ADDENDUM		4-29-91	
NO.	REVISION	DATE	BY
FIRE MARSHAL			
O.S.A.

(AIR CONDITIONING)
 HORT SCHOOL
 BAKERSFIELD CITY SCHOOL DISTRICT
 2301 PARK DRIVE, BAKERSFIELD, CALIFORNIA

JOB NO. 142
 SHEET NO. ADI-1-MP5
 SHEET 5 OF 6

CONTROL SITE PLAN

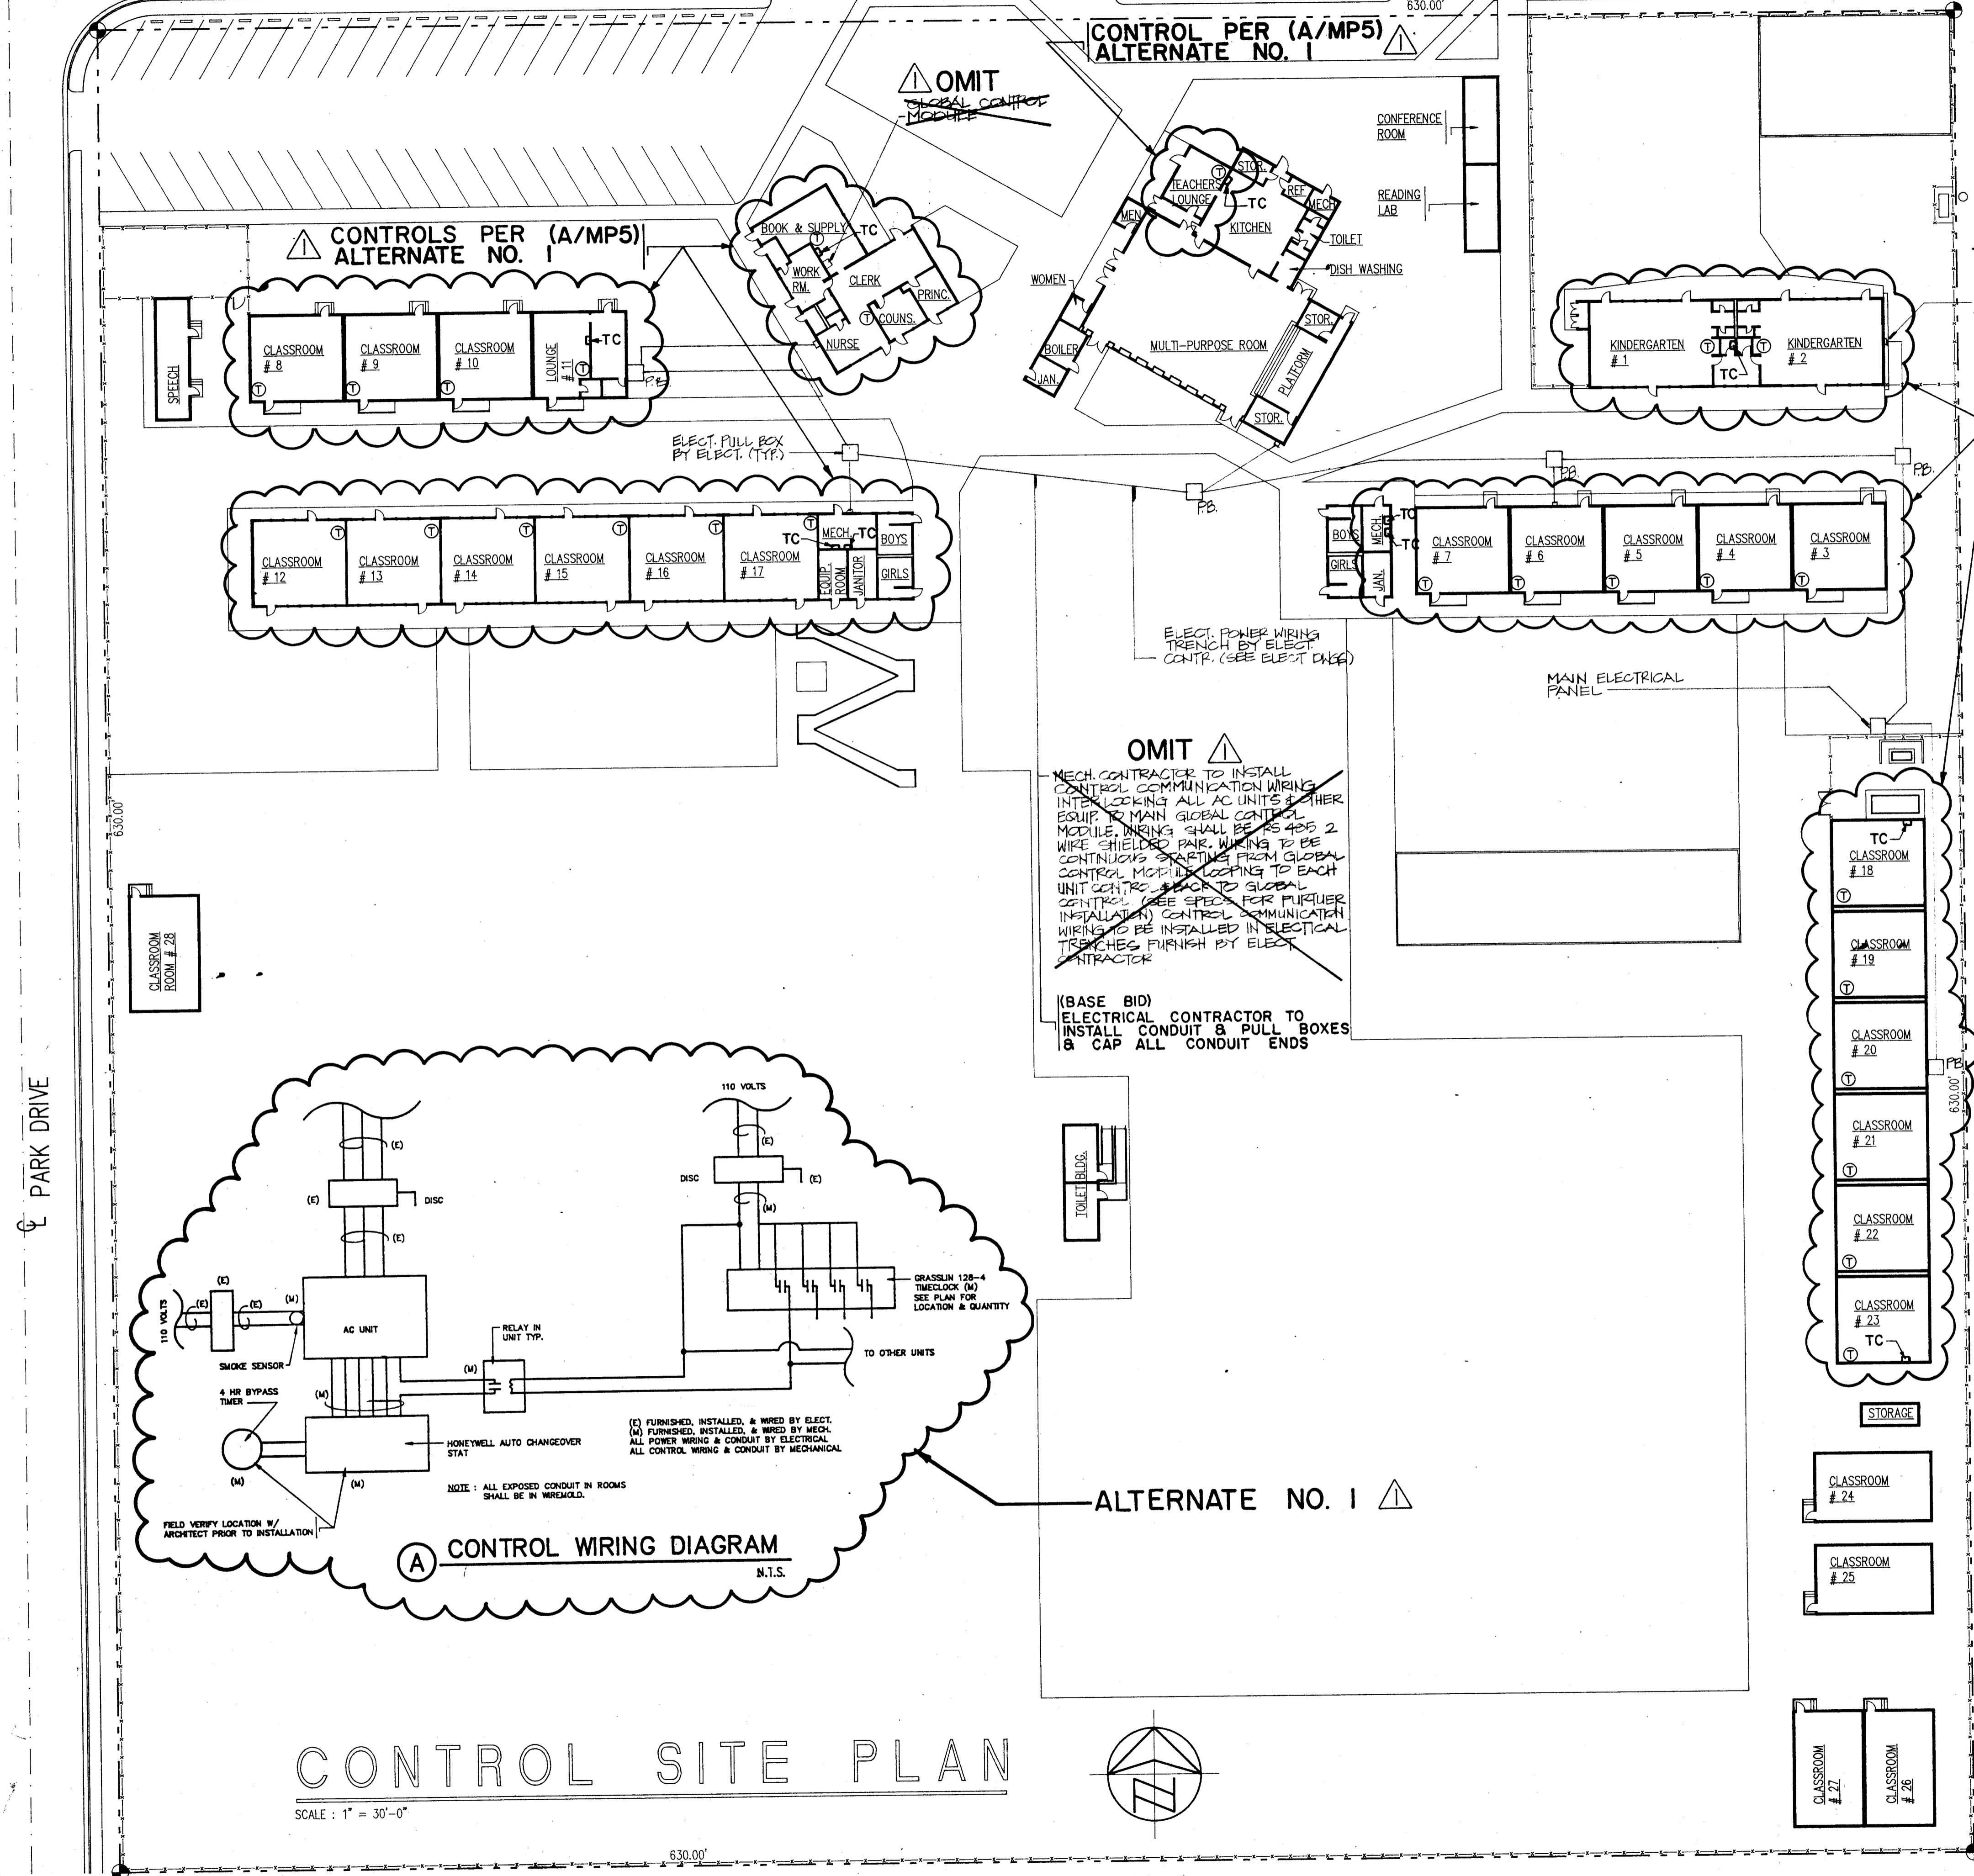
~~OMIT~~
CENTRAL COMMUNICATION WIRING TO RISE FROM BELOW FLOOR IN CONDUIT & EXTEND TO UNITS (TYP)

~~OMIT~~
MECH. CONTRACTOR TO INSTALL CONTROL COMMUNICATION WIRING INTERLOCKING ALL AC UNITS & OTHER EQUIP. TO MAIN GLOBAL CONTROL MODULE. WIRING SHALL BE AS 405 2 WIRE SHIELDED PAIR. WIRING TO BE CONTINUOUS & RATING FROM GLOBAL CONTROL MODULE TO EACH UNIT CENTER & BACK TO GLOBAL CONTROL. (SEE SPEC. FOR FURTHER INSTALLATION) CONTROL COMMUNICATION WIRING TO BE INSTALLED IN ELECTRICAL TRENCHES FURNISH BY ELECT. CONTRACTOR

(BASE BID) ELECTRICAL CONTRACTOR TO INSTALL CONDUIT & PULL BOXES & CAP ALL CONDUIT ENDS

(A) CONTROL WIRING DIAGRAM
N.T.S.

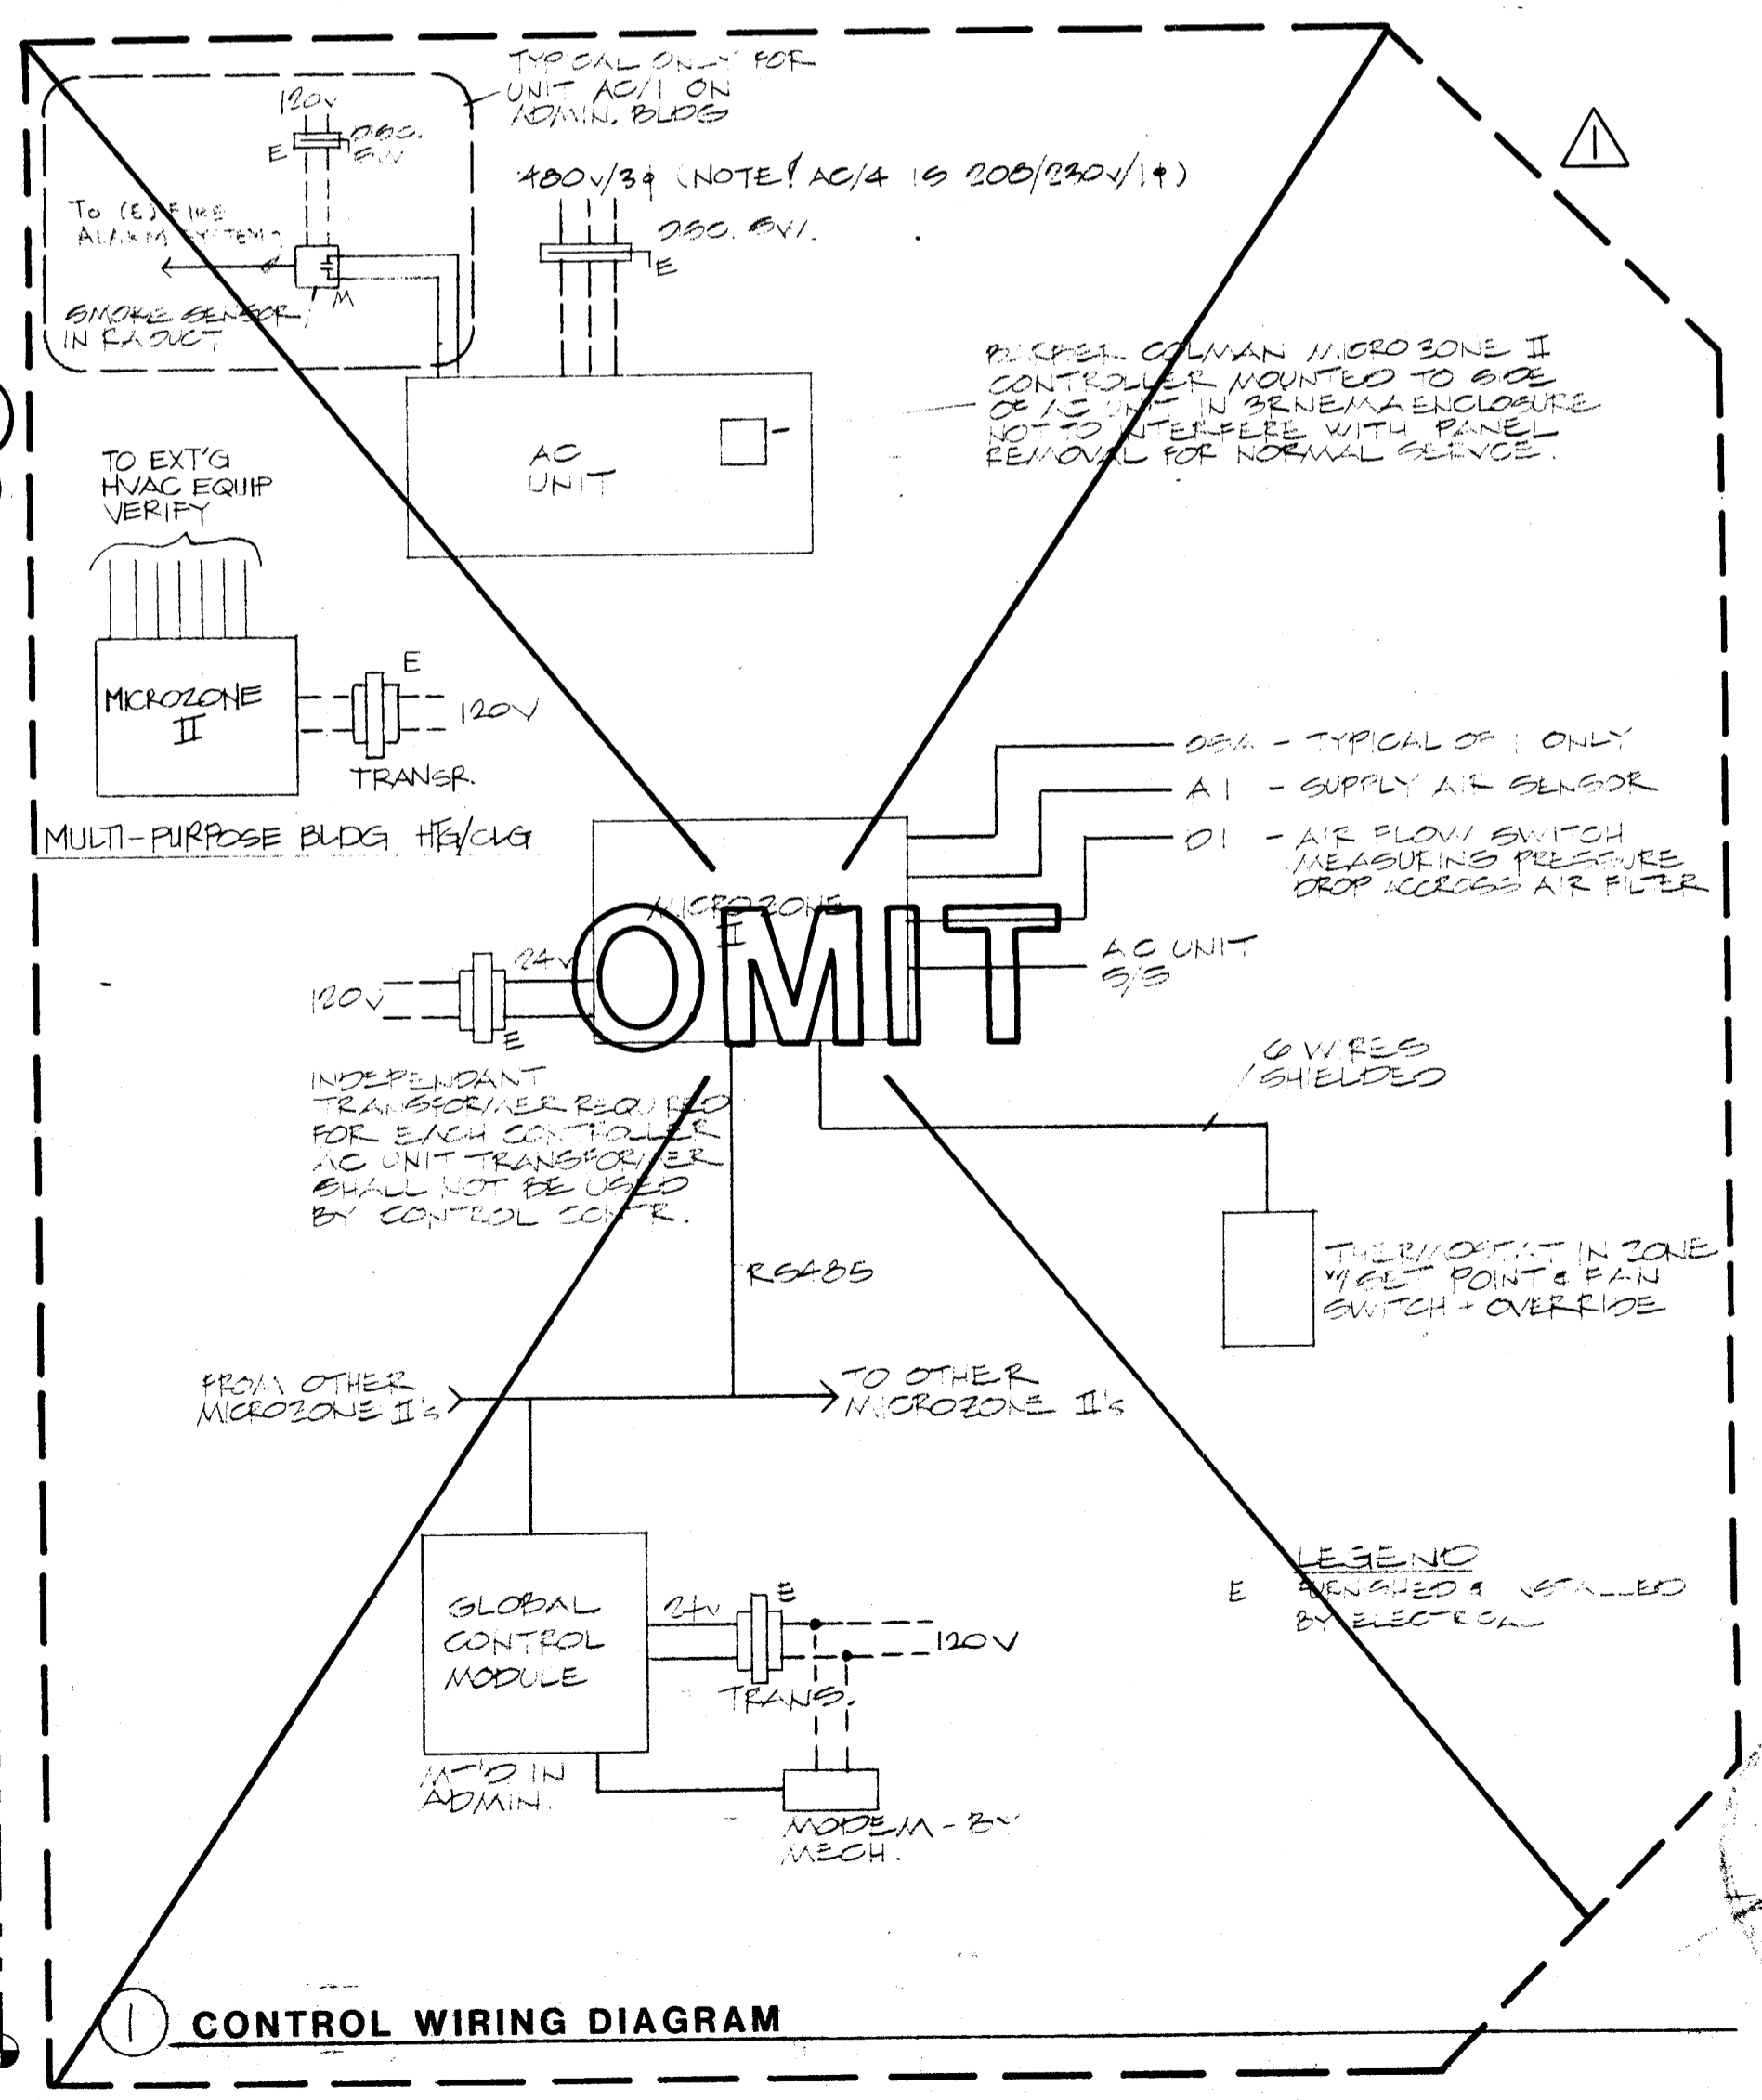
CONTROLS PER (A/MP5) ALTERNATE NO. 1
